Record of Telephone Conversation 7/15/81
 Midland Project - Surcharging valve pits near Bechtel Water Tanks

MIDLAND PROJECT

BOARATED WATER STORAGE TANK (BWST) - SURCHARGE PROGRAM

SUBJECT: TELEPHONE CONFERENCE ON JULY 15, 1981 ON BWST
SURCHARGE PROGRAM

FIGURE 1

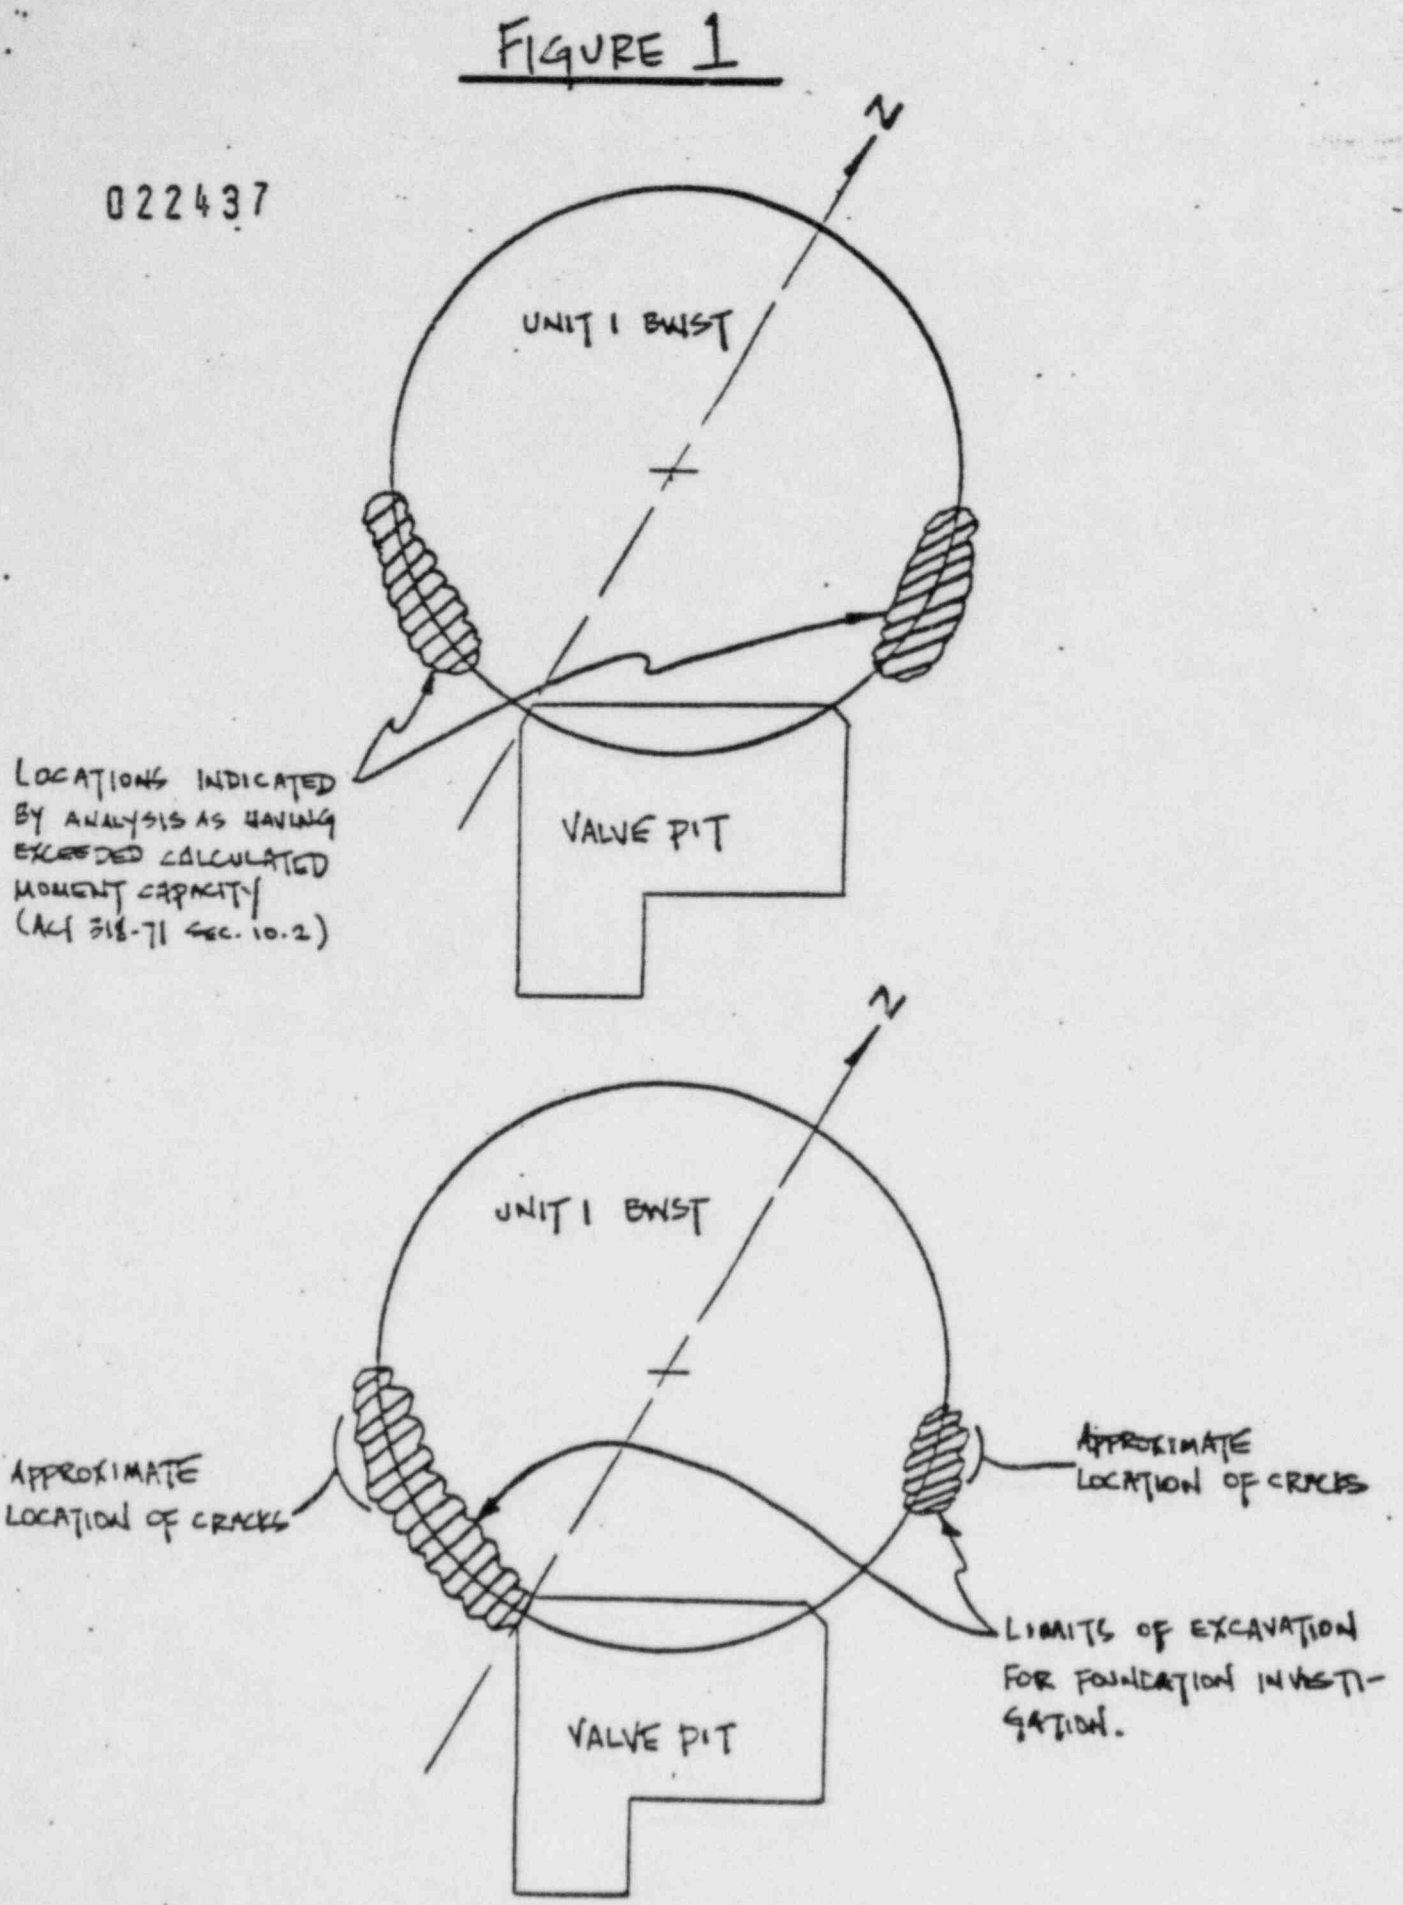
During the load test on the Unit 1 tank (conducted in compliance with the response to 10 CFR 50.54(f), Question 4), a discrepancy was noted between measurements of settlements recorded at the jobsite and the computed displacements derived from the structural analysis used at that time. As a result, the analysis was modified to include a finite element model of the soil subgrade. A number of analyses were completed using various values for the modulus of elasticity (E) of the soil. The results of the analyses predicted that greater than allowable moments existed at several locations in the foundation structure (see Figure 1).

The foundation at these locations was examined to verify whether visible signs of high reinforcement strain existed. Cracks were found in the structure at those locations indicated by the analysis as having greater than allowable moments. The largest crack measured 0.063 inch. Subsequently, the Unit 2 tank foundation was also examined; similar cracks were found, and the largest crack measured 0.035 inch. The smaller bearing area of the Unit 2 valve pit partially explains why the cracks in the Unit 2 tank foundation are smaller than the cracks in the Unit 1 tank foundation.

FIGURE 2

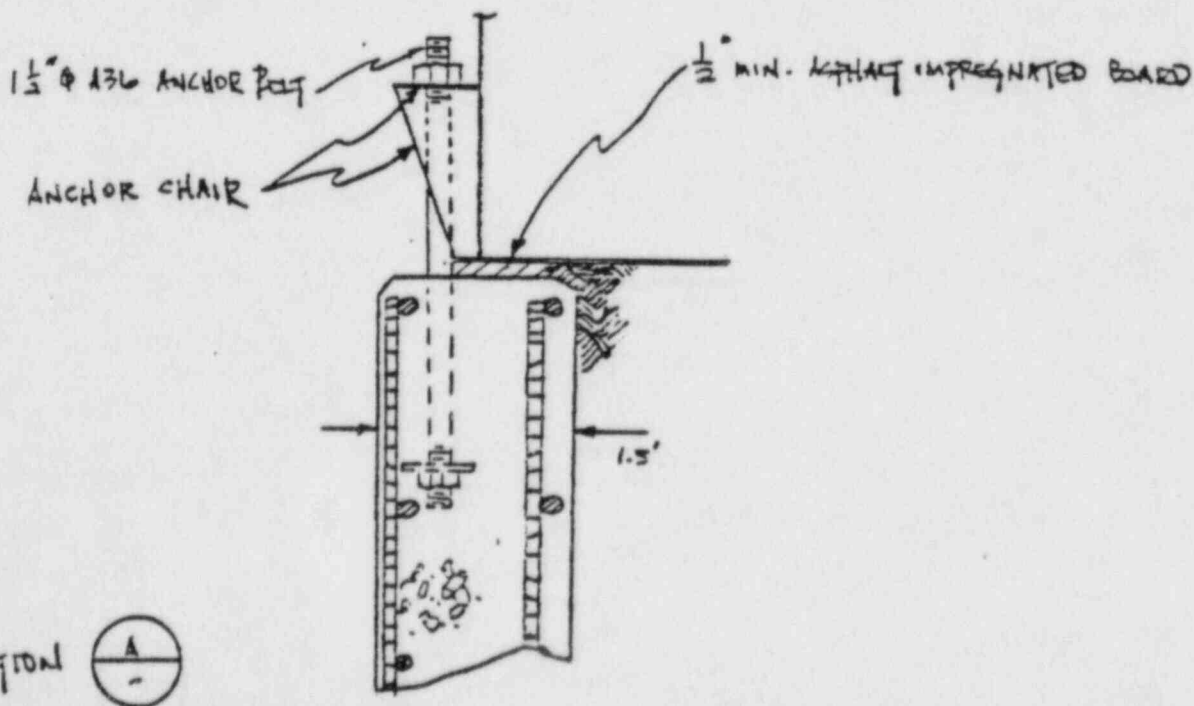
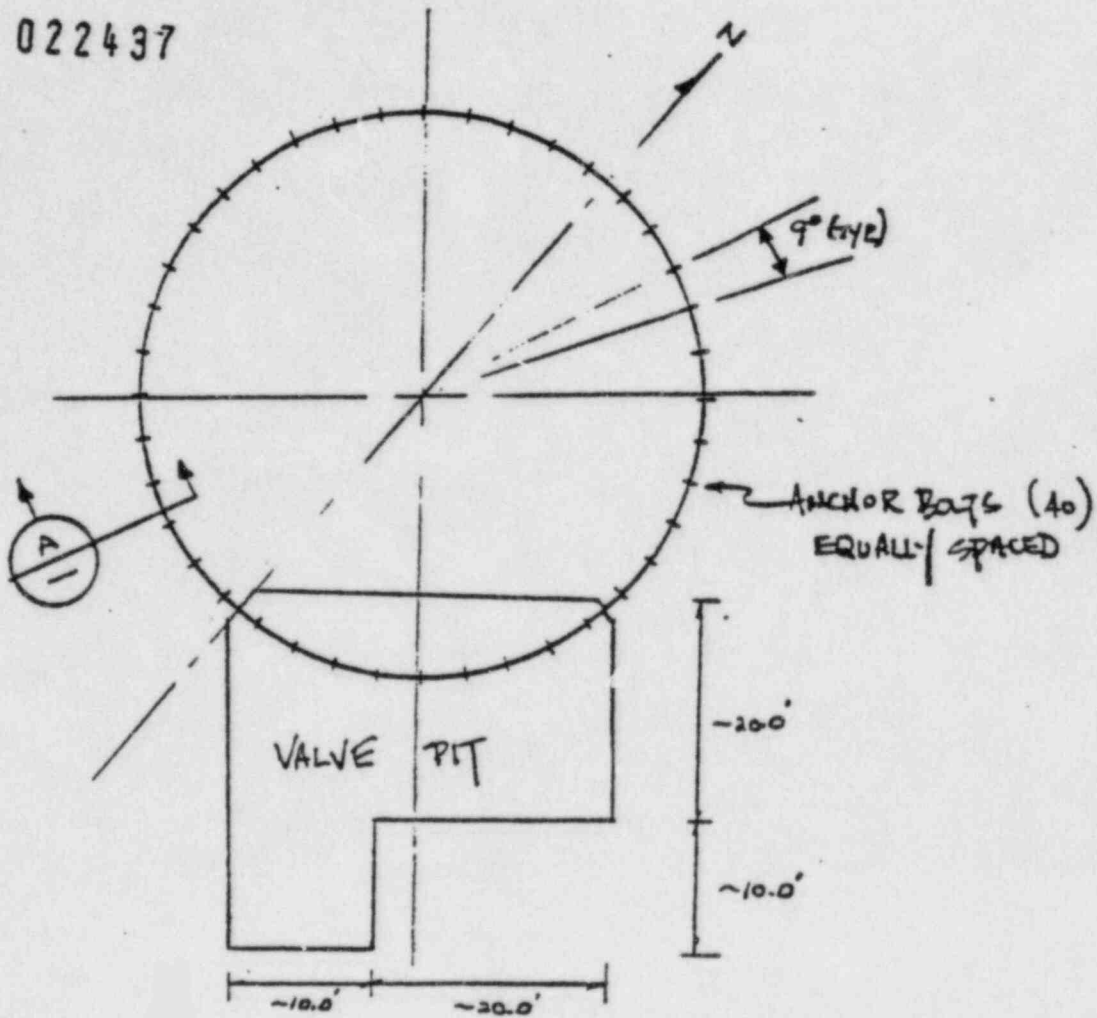
The cracks in the foundation structure of the Unit 1 tank indicate that high reinforcement strain exists in the ring wall foundation. As shown in Figure 2, the tank's outside periphery is attached to the ring wall foundation by equally spaced anchor bolts that transfer induced forces through an anchor chair. A check with jobsite construction personnel indicated that all anchor bolts were installed in a snug-tight condition

consistent with installation requirements and were in contact with the top of the anchor chair when the tank was erected. However, recent field observations indicate that gaps exist between the anchor bolt nut and anchor bolt chair in several locations around the periphery of the tank; whereas, in other locations the horizontal plates of the anchor bolt chairs are deflected, indicating high tensile stress in the bolts.

This anchor bolt behavior results from the distortion of the foundation ring which is caused by differential settlement; this agrees with the conclusions of the modified structural analysis. The tension induced in the bolts is similar to the tension induced by a preload phenomenon and does not affect the ability of the bolts to resist design loads. Although the ring wall is cracked, it is capable of providing the necessary dead load anchorage for the anchor bolts and confinement of the tank foundation support material. Therefore, resistance will be provided for externally applied forces which induce tension in the anchor bolts.

Figure 3

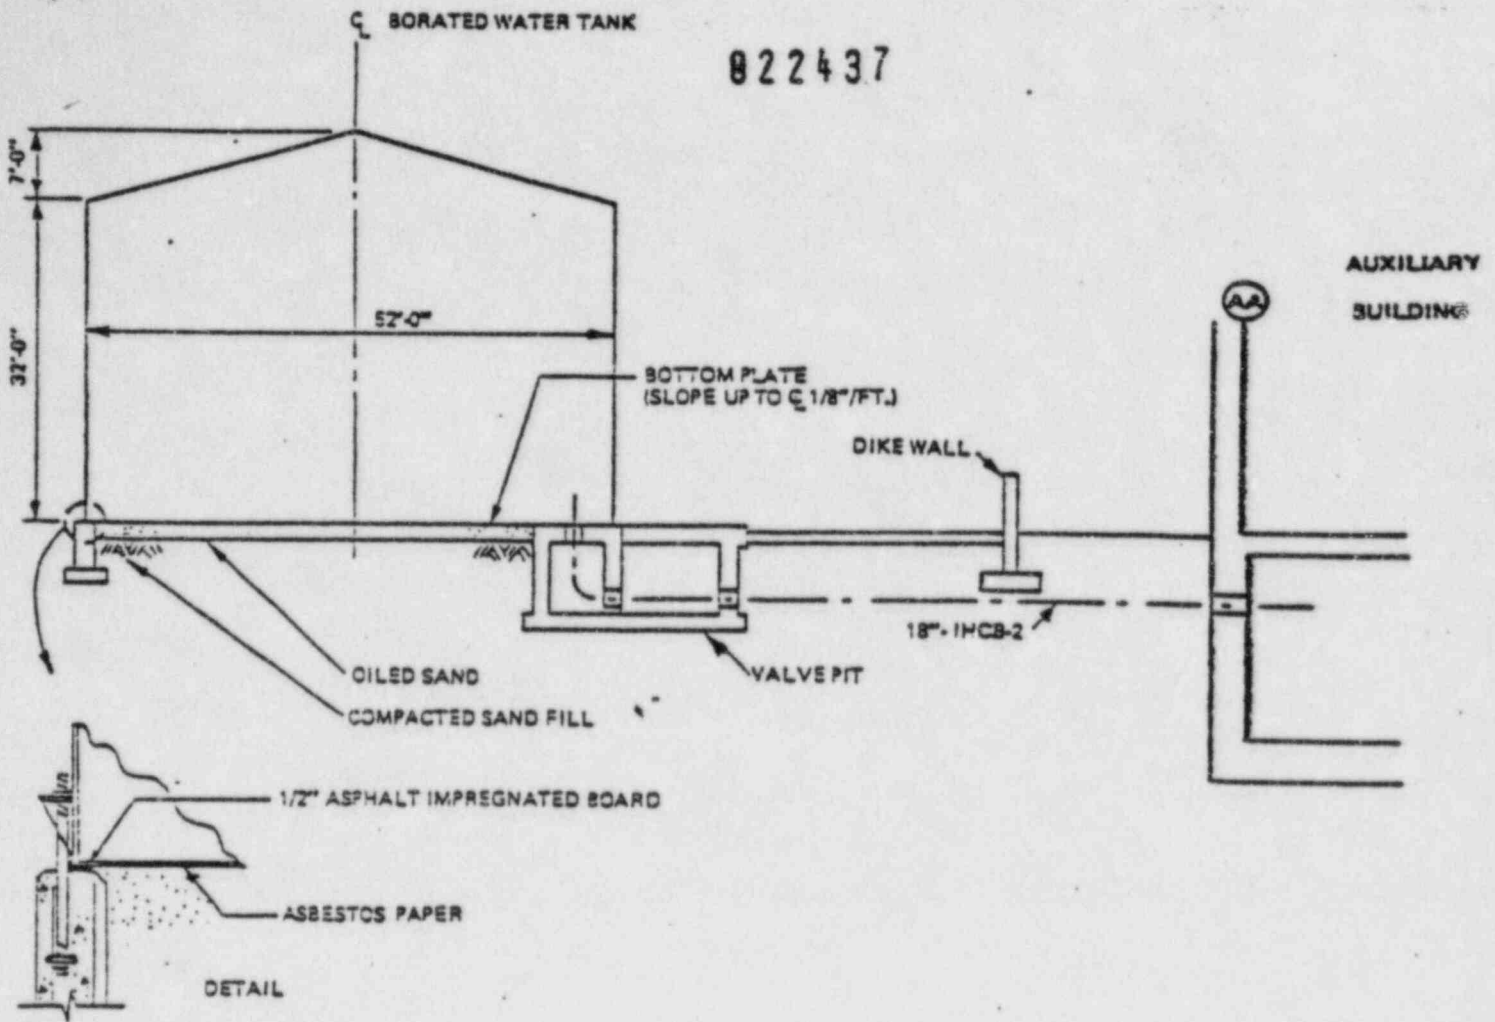
The 52-foot diameter, stainless steel borated water storage tanks are 32 feet high and rest on compacted, granular backfill material contained within a reinforced-concrete ring wall. On one side is an integral valve pit that houses connections and valves for the two 18-inch diameter pipelines that service each tank. Figure 31.1 from the response to NRC 10 CFR 50.54(f), Question 31 is attached for reference (see Figure 3).
